**Subject:** TX SO2 modeling - Martin Lake

**Responses to Significant Comments on the Designation  
Recommendations for the 2010 Sulfur Dioxide National Ambient  
Air Quality Standards (NAAQS) – Supplement for Four Areas in  
Texas Not Addressed in June 30, 2016, Version**

Docket Number EPA–HQ–OAR–2014–0464  
U.S. Environmental Protection Agency

November 29, 2016

Figure 1. Overall good agreement for all hours by AERMOD for the Shotts Monitor

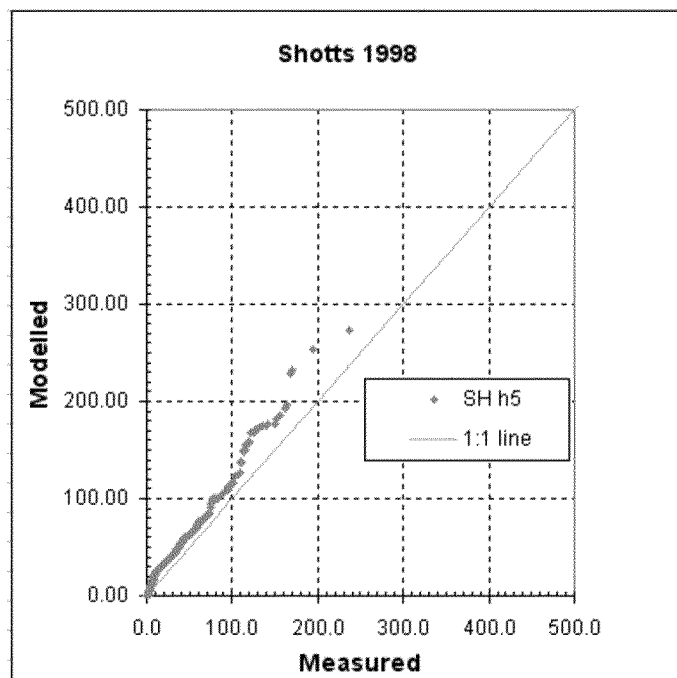
The alternate DV calculations Luminant included that used Sierra Club's 2015 modeling for 2012-2014 is fundamentally flawed by their use of the 50% discounting factor. Luminant took 2012 maximum values and scaled the value down using a ratio of 2015 SO<sub>2</sub> emissions divided by 2012 SO<sub>2</sub> emissions (used the emission ratio times the 2012 Highest 4<sup>th</sup> High). Luminant then used this scaled 2015 estimate based on Sierra Club modeling results for 2012 to estimate a new DV using the 2013 and 2014 Sierra Club results to estimate an artificial DV value for 2013-2015 for Big Brown and Martin Lake. These values were above the NAAQS, so Luminant utilized their proposed 50% discounting factor to further adjust these back of the envelope type estimates. The use of the 50% discount factor is not appropriate and the unadjusted DV was above the standard for Big Brown and Martin Lake.

The commenter is also not considering that the same times that they have identified are some of the meteorological conditions that do result in higher ground level impacts. So to identify all of these occurrences using the debugging output tool blankets all such conditions as suspect, when in reality this is one of the types of meteorological/dispersion situations that leads to higher impacts that can impact the DV.

Furthermore, adjusting modeling results based on a one or two modeling scenario comparisons to a few monitors is not appropriate and such approaches of attempting to calibrate the model results are prohibited by the **Guideline on Air Quality Models {GAQM}** (40 CFR Part 51 App. W 7.2.9 Calibration of Models; November 9, 2005).

**Figure 2. Increase in stack temperature (degrees K) due to AERLIFT preprocessing for Big Brown. The line of the stacks is denoted by the red line.**

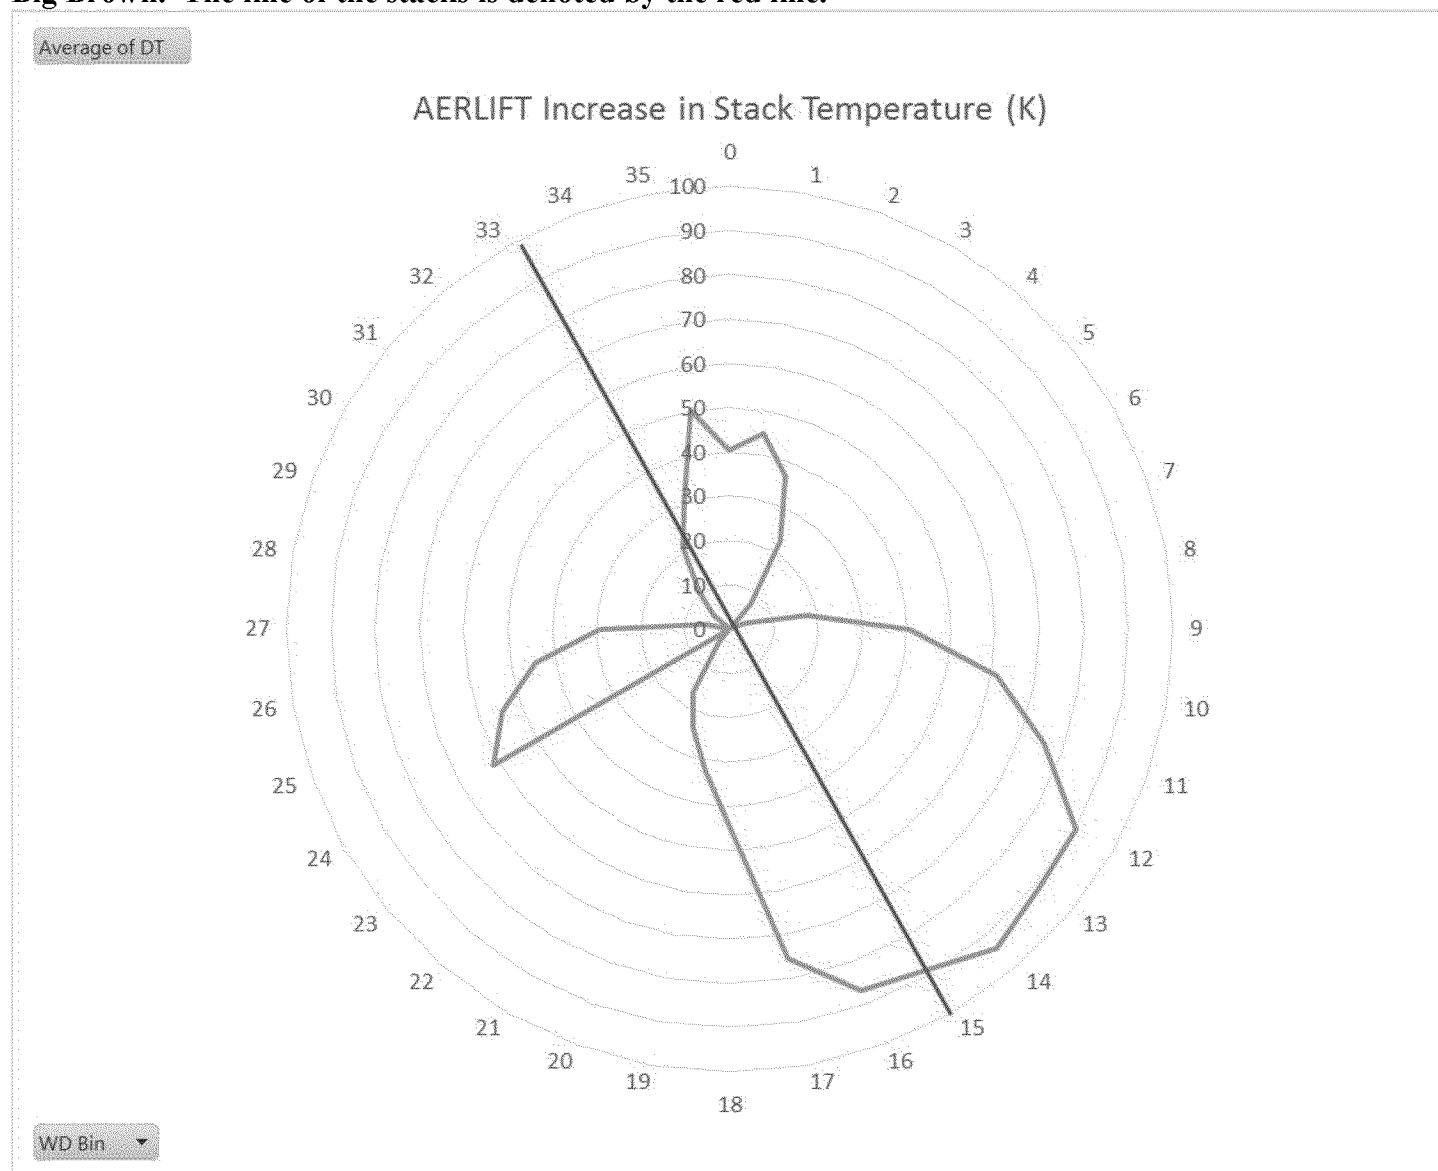
To get an idea of the degree of changes made by the AERLIFT implementation submitted by Luminant, a review of the modifications made to the observed stack parameters was conducted by EPA Region 6. This review was conducted by comparing the original CEM data to the AERLIFTed parameters. The review showed that the stack temperature can be increased during individual hours by as much as 200 K by the AERLIFT preprocessor. To put this modification to stack gas temperature in context, the wet scrubbed plumes are approximately 80-90 K above ambient conditions, so these adjustments would drastically impact the amount of buoyancy estimated in the model and ultimate plume rise and would result in large differences in modeled ground concentrations around the source.

The figure below of the *average* temperature increase by wind direction demonstrates for some wind directions AERLIFT increases the average stack temperature by over 90K. The AERLIFT model also seems to be increasing the stack temperature for wind directions that are not roughly in line with the stacks (331 and 151 degrees K). These temperature changes with the accompanying stack gas exit velocity increases raise the average buoyancy flux of the emissions by up to 50% for some wind directions. For certain hours the increase is far greater. Such changes in the modeled buoyancy of the plume are expected to have a major effect on the location and concentrations of maximum ground level impact. These changes seem disproportionately large and the impacts they would have on the modeling are very significant. Prior to use in a regulatory setting EPA believes that the particular implementations of AERLIFT needs to undergo extensive review versus test cases previously used for AERMOD model review. While the scientific principles seem like these might be refinements, it has not been substantiated that the implementation of these pre-processors and their coding is a refinement within AERMOD modeling platform and a full review as required by EPA for regulatory models has not been completed. There is no information to support that Luminant's modeling results with the AERLIFT processor meets the requirements for models used in a regulatory decision. It is premature to use AERLIFT in this context for informing our designation decisions.

**Figure 5. Sierra Club's Maximum Predicted 99<sup>th</sup> Percentile 1-Hour SO<sub>2</sub> Concentrations in the Freestone County Area of Analysis Based on Actual Emissions**

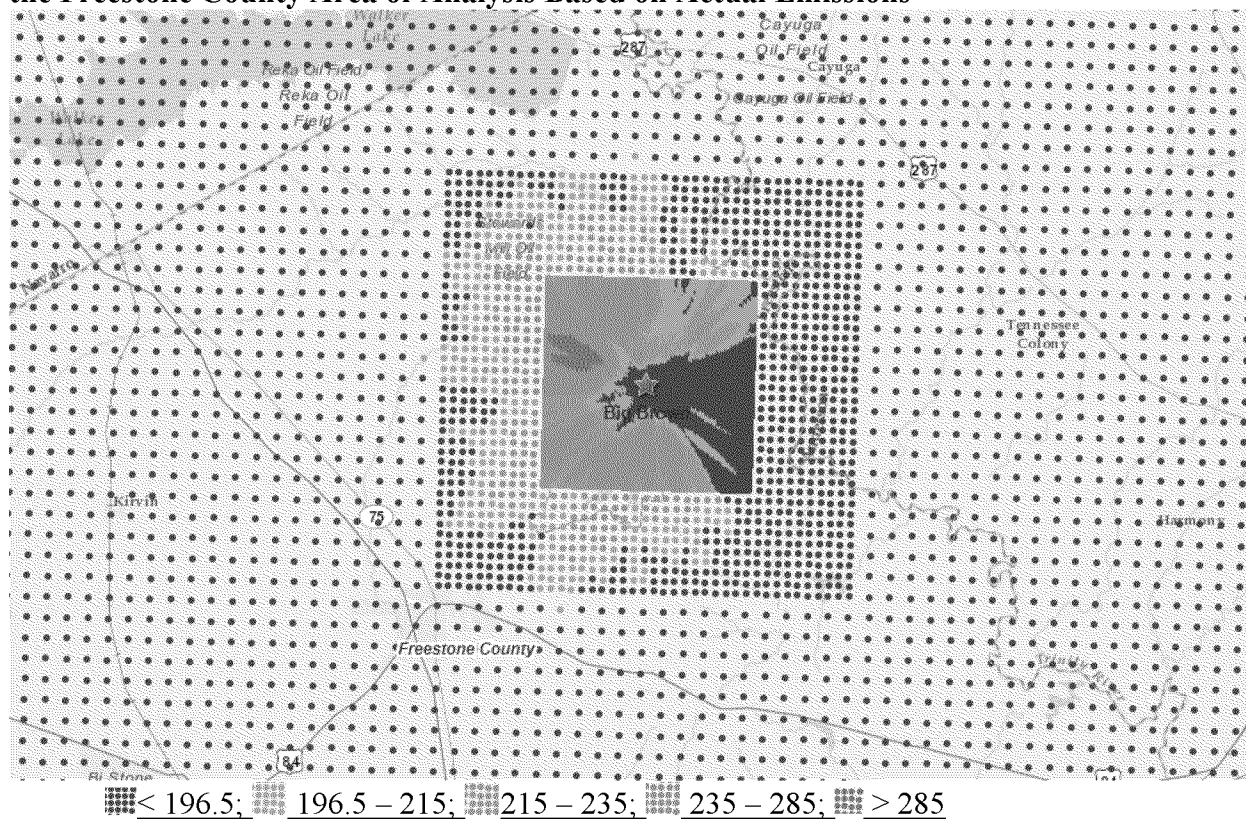
The Sierra Club's modeling indicates that the highest predicted 3-year average 99<sup>th</sup> percentile 1-hour average concentration within the chosen modeling domain is 321 µg/m<sup>3</sup>, or 123 ppb. This modeled concentration included the assumed background concentration of SO<sub>2</sub>, and is based on actual emissions from the Big Brown Steam Electric Station. Figure 5 below was included as part of Sierra Club's updated submission and indicates that the predicted value occurred to the WNW of Big Brown. Most of the Sierra Club's chosen receptor grid is also shown in the figure.

Luminant provided a figure in their modeling report indicating the area that they did not think was available for siting a monitor based on exclusion within their property line and also lake/wetland areas. See Figure 6 below.

Luminant did not provide a detailed analysis of appropriate fencing and limiting of access to their property (necessary to determine if an area is actually not ambient air), nor other material documenting exclusion due to over water, etc. in support of the areas they have excluded. From the information we do have, and evaluation with GIS/aerial data, we have concerns that Luminant has excluded more areas than are appropriate. Regardless, we still have adequate information to conclude whether the area is attaining the 2010 SO<sub>2</sub> NAAQS, given that adequate modeling shows values over the standard outside the areas excluded by Luminant, in undisputed ambient air. We note that Figure 6 also excludes parts of some roadways that are not limited to Luminant access only (appear to be County and Farm to Market Roads 235, 833, 2570) and associated right of ways in their exclusion. These are areas that we would consider to be ambient air and potentially available for monitor siting. Receptors should have been placed between the fenceline and the public road in the right of ways. The maximum modeled values are to the west-northwest of the facility and beyond the area that Luminant/AECOM has excluded. The area of darker orange in Figure 5 is almost entirely ambient based on Luminant's map. There are 8-10 receptors at most that are closest to the facility (east edge of the dark orange receptors) that appear to be potentially within Luminant's property. The maximum and most of the receptors with values above 290 µg/m<sup>3</sup> are in ambient air. Therefore, there are many receptors well above the standard that are in ambient air.

**Figure 14. Luminant's Near Field Receptor Grid with Area excluded by Luminant based on property boundaries or lake/wetland areas.**

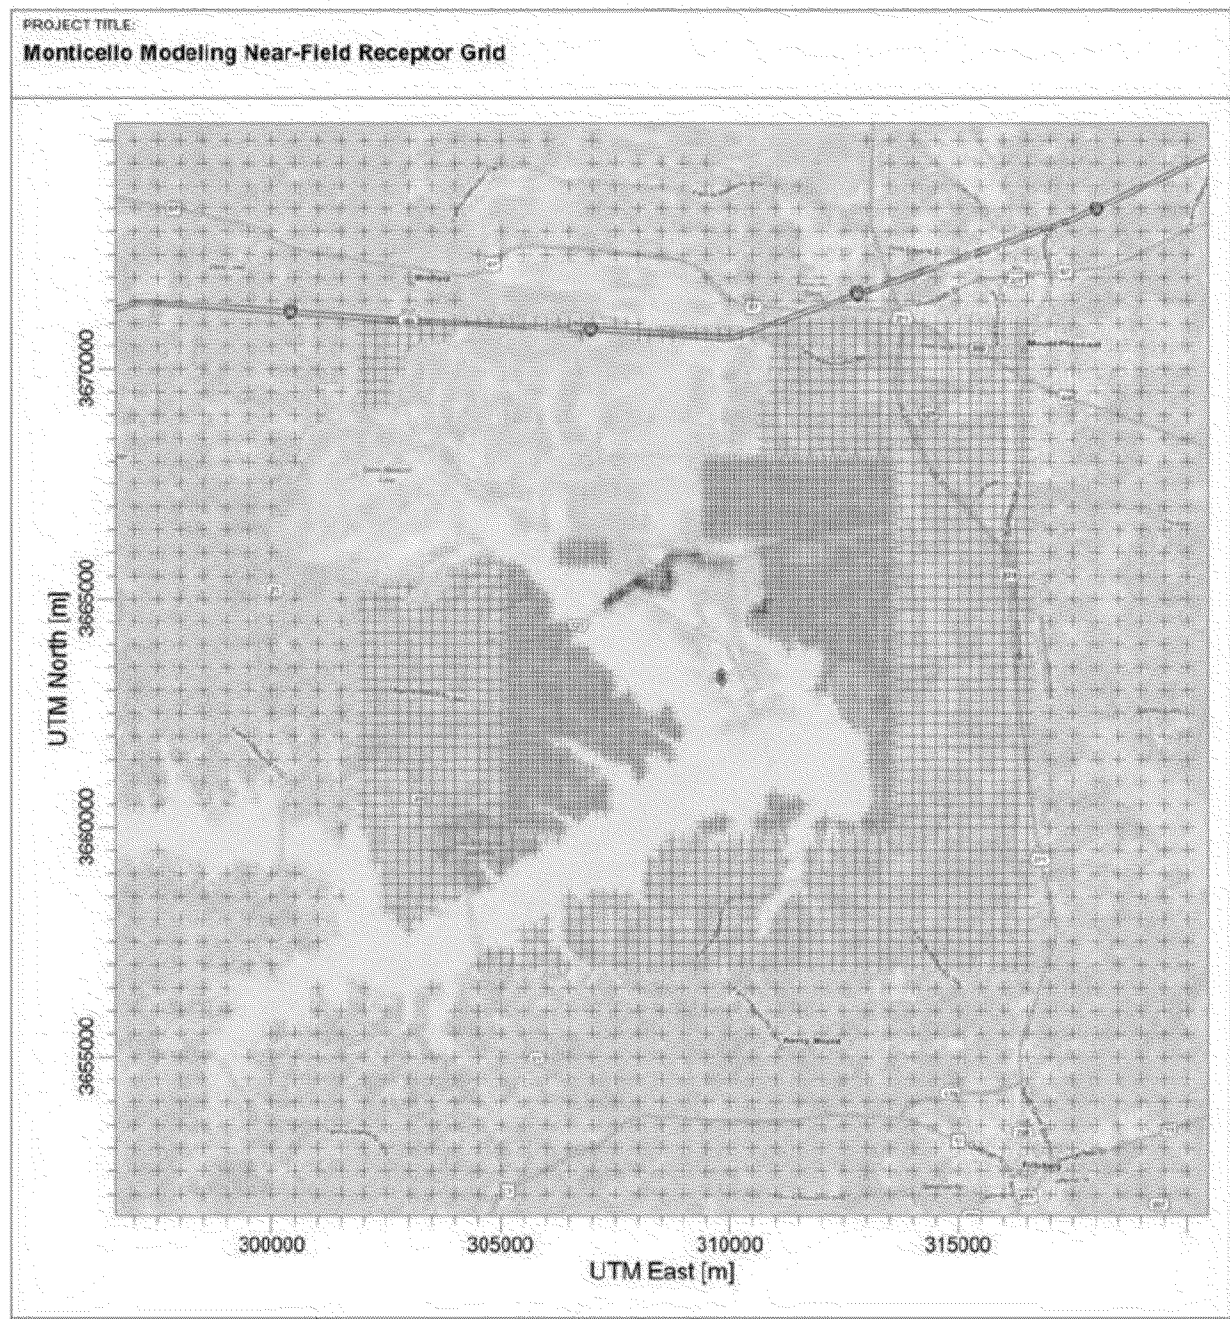
We note that Luminant included a figure with their near field receptors grid and they indicated that they excluded areas that were within their property line or lake/wetland areas. Luminant did not provide a detailed analysis of appropriate fencing and limiting of access to their property (necessary to determine if an area is actually not ambient air), nor other material documenting exclusion due to over water, etc. in support of the areas they have excluded. From the information we do have, and evaluation with GIS/aerial data, we have concerns that Luminant has excluded more areas than are appropriate. Regardless, we still have adequate information to

conclude whether the area is attaining the 2010 SO<sub>2</sub> NAAQS, given that adequate modeling shows values over the standard outside the areas excluded by Luminant, in undisputed ambient air. We have analyzed the information (See Figure 14) and determined that the area that is shown to be above the standard in the Figure above is all ambient air and not within Luminant's fenceline.

**Figure 16: The average increase in stack temperature (degrees K) due to AERMOIST and AERLIFT preprocessing for Martin Lake.**

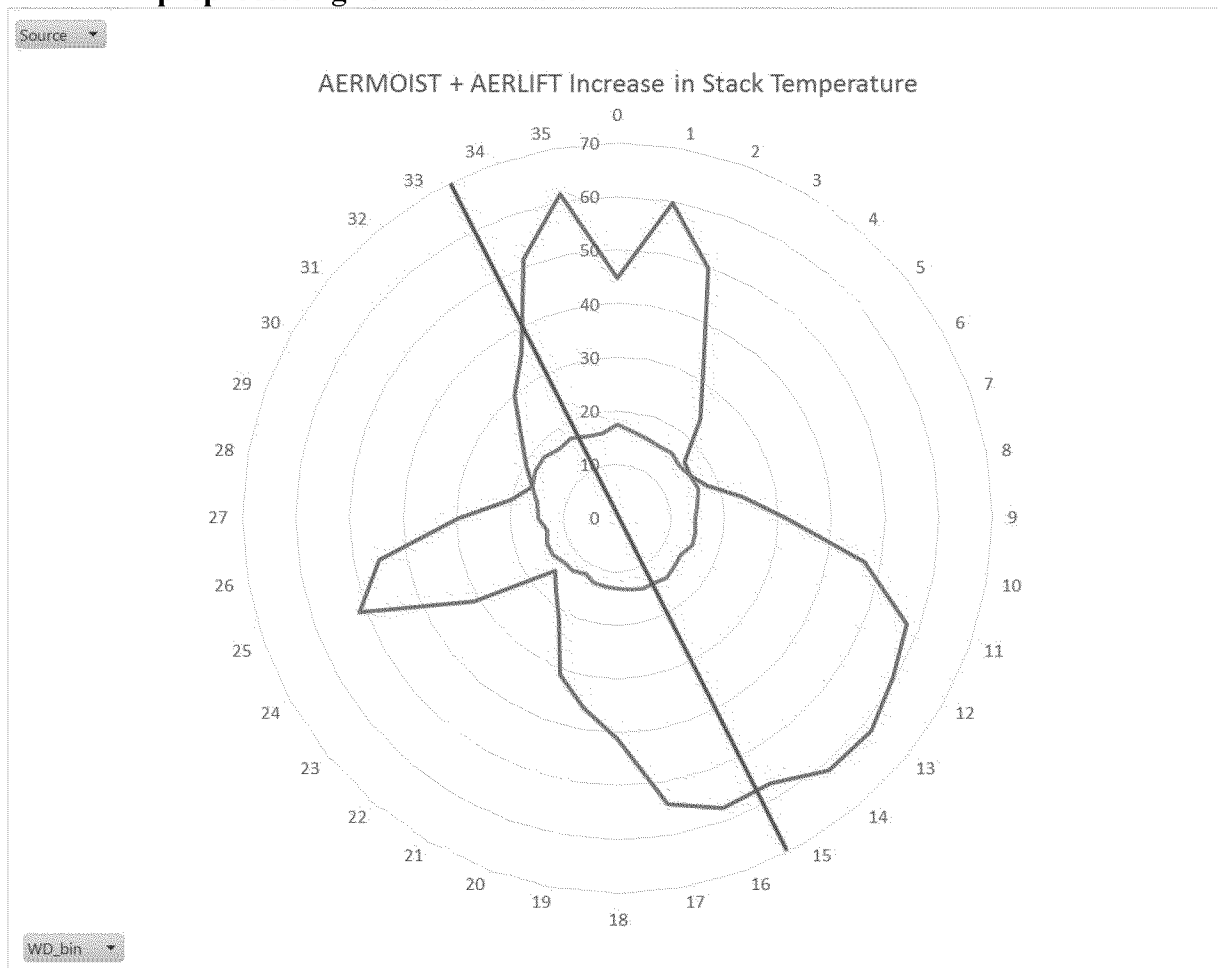
To get an idea of the degree of changes made by the AERMOIST and AERLIFT implementations submitted by Luminant, a review of the modifications made to the observed stack parameters was conducted by EPA Region 6. This review was conducted by comparing the original CEM data to the AERMOIST and AERLIFT adjusted temperatures and velocities provided by Luminant. The review showed that the stack temperature can be increased during individual hours as much as 300K by the combination of the AERMOIST preprocessor followed by the AERLIFT preprocessor. In Figure 16 below a plot of the *average* temperature increase by wind direction for each preprocessor demonstrates for some wind directions AERMOIST+AERLIFT increases the average stack temperature by over 60K. The AERLIFT model also seems to be increasing the stack temperature for wind directions that are not roughly in line with the stacks (334 and 154 degrees). These temperature changes with the accompanying stack gas exit velocity increases raise the average buoyancy flux of the emissions

by 70% for some wind directions. For certain hours the increase is far greater. Such changes in the buoyancy of the plume are expected to have a major effect on the location and concentrations of maximum ground level impact. These changes seem disproportionately large and the impacts they would have on the modeling are very significant. Prior to use in a regulatory setting EPA believes that the particular implementations of AERMOIST and AERLIFT need to undergo extensive review versus test cases previously used for AERMOD model review. While the scientific principles seem like these might be refinements, it has not been substantiated that the implementation of these pre-processors and their coding is a refinement within AERMOD modeling platform and a full review as required by EPA for regulatory models has not been completed. There is no information to support that Luminant's modeling results with the AERLIFT and AERMOIST processors meet the requirements for models used in a regulatory decision. It is premature to use AERMOIST and AERLIFT in this context for informing our designation decisions.

**Figure 20. Area excluded by Luminant based on assertion that receptors were within property boundaries or were lake/wetland areas.**

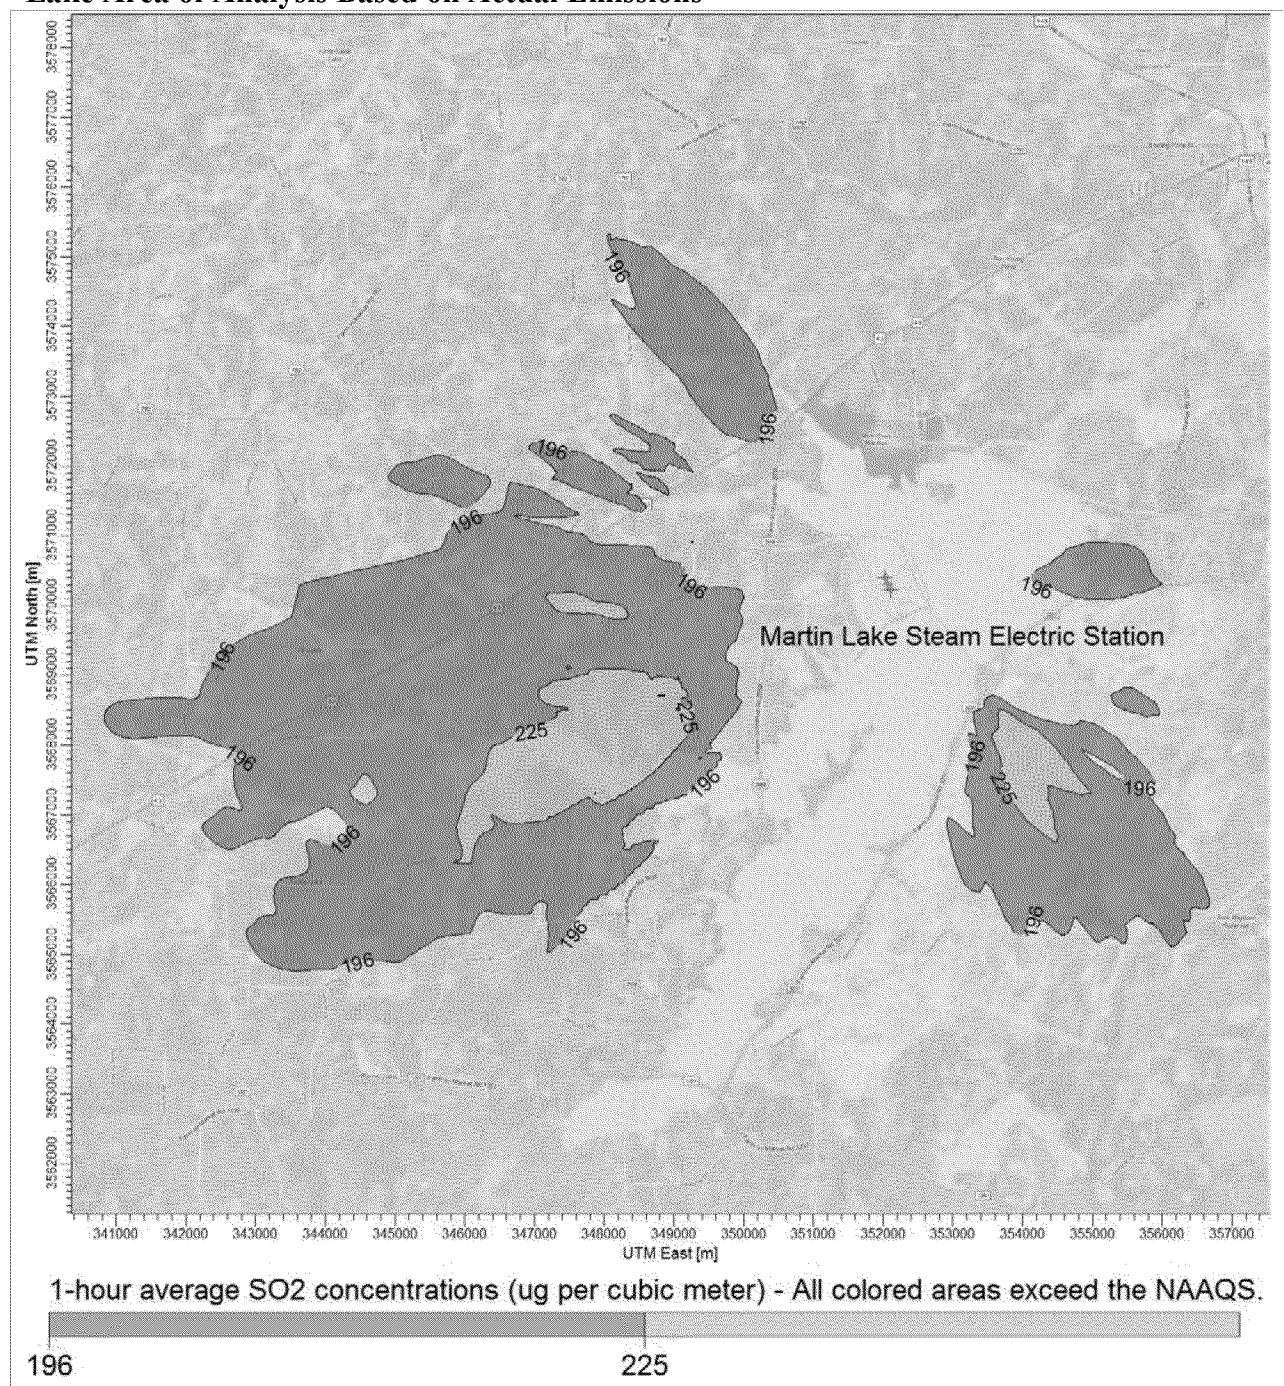
Luminant provided a figure in their modeling report indicating the area that they did not think was available for siting a monitor based on exclusion within their property line and also lake/wetland areas. See Figure 20 below. Luminant did not provide a detailed analysis of appropriate fencing and limiting of access to their property (necessary to determine if an area is actually not ambient air), nor other material documenting exclusion due to over water, etc. in support of the areas they have excluded. From the information we do have, and evaluation with GIS/aerial data, we have concerns that Luminant has excluded more areas than are appropriate. Regardless, we still have adequate information to conclude whether the area is attaining the 2010 SO<sub>2</sub> NAAQS, given that adequate modeling shows values over the standard outside the areas excluded by Luminant, in undisputed ambient air. We note that Figure 20 also excludes parts of some roadways that are not limited to Luminant access only (appear to be Farm to Market 2658 and County Roads 3231, 2144, 2145, 2126, 2138, etc.) and associated rights of way in their exclusion. We also note that it appears that there are houses in some areas that are excluded in the figure provided by Luminant (personal property along FM 2658 etc.) that Luminant could not control access to and has erroneously marked as not available for monitor siting. These are areas that we would consider to be ambient air and potentially available for monitor siting. Receptors should also have been placed between the fenceline and the public road (in the rights of way). The maximum modeled values are to the west (areas that Luminant did not exclude) and southwest of the facility where Luminant have excluded but have not provided sufficient information to verify the property (if owned) is truly limited access/non-ambient air. The maximum value (249.3 µg/m<sup>3</sup>) in the Sierra Club modeling is in this area to the southwest that Luminant has excluded. Regardless there are exceedance areas in multiple directions from Martin Lake units that are not contested by Luminant and are clearly ambient:

The area of yellow contour values (above 225 µg/m<sup>3</sup>) in Figure 19 appear to be mostly in areas excluded by Luminant. As discussed before it is unclear if all of these are truly non-ambient receptors.
